Affected Models: 7T84JHA, 7T84JUA, T90BW
Affected S/N Range: Engine Serial number 7/2018- 7/2020

Affected Parts: 794-00136; 994-00136 Ignition Coil

Date: October 8, 2020

Subject: Cold No Starts or Sticking Choke Interference found

Figure 1

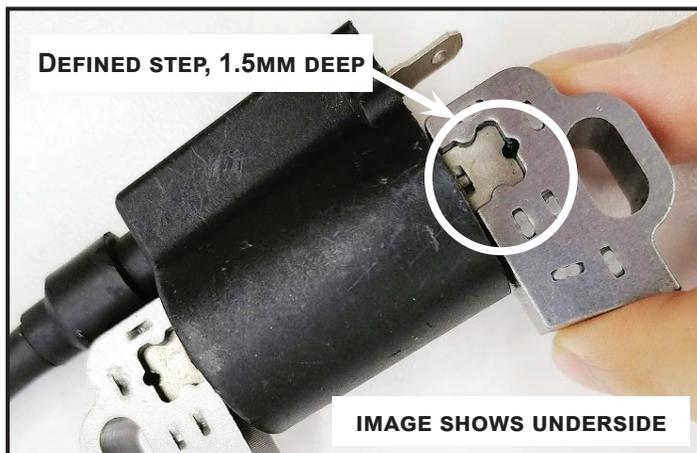
Purpose: Correcting a sticking Air Vane due to interference with the Ignition Coil wire. A step in the laminate core allows the Air Vane to move directly into the Coil wire. The Ignition Coil must be replaced to correct this interference.

1. Identify a bad Ignition Coil. Remove Ignition coil from Engine. Turn over and inspect the underside. An Ignition coil with a 1.5mm step from the laminate core is a bad coil. See Figure 1.

3. When a bad ignition coil is found, it is in need of replacement. Order and install Ignition coil 994-00136.

NOTE: To reinstall new coil: Set air gap of coil at 0.016"-0.024". Tighten the module mounting screws to a torque of 80-106 in-lbs (9-12 Nm).

Figure 2

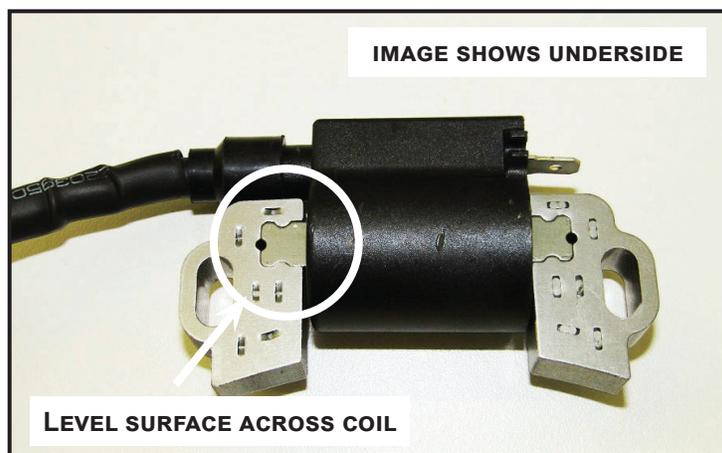
2. Identify a good Ignition Coil. A good coil will not have a step from the laminate core. See Figure 2.
